UNITED STATES PATENT AND TRADEMARK OFFICE

APPLICATION NO.	FILING DATE	FIRST NAMED INVENTOR	ATTORNEY DOCKET NO.	CONFIRMATION NO.
10/064,822	08/21/2002	Dennis B. Hansen	02H1584	9781
24234	7590	04/06/2004	EXAMINER	
SIMMONS, PERRINE, ALBRIGHT & ELLWOOD, P.L.C. THIRD FLOOR TOWER PLACE 22 SOUTH LINN STREET IOWA CITY, IA 52240			POPOVICS, ROBERT J	
			ART UNIT	PAPER NUMBER
			1724

Office Action Summary

DETAILED ACTION

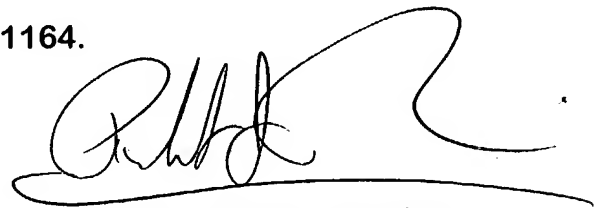
7. The drawings are objected to as failing to comply with 37 CFR 1.84(p)(5) because they do not include the following reference sign(s) mentioned in the description: the filter illustrated in Fig. 2 has no reference numeral illustrated.

A proposed drawing correction or corrected drawings is requested.
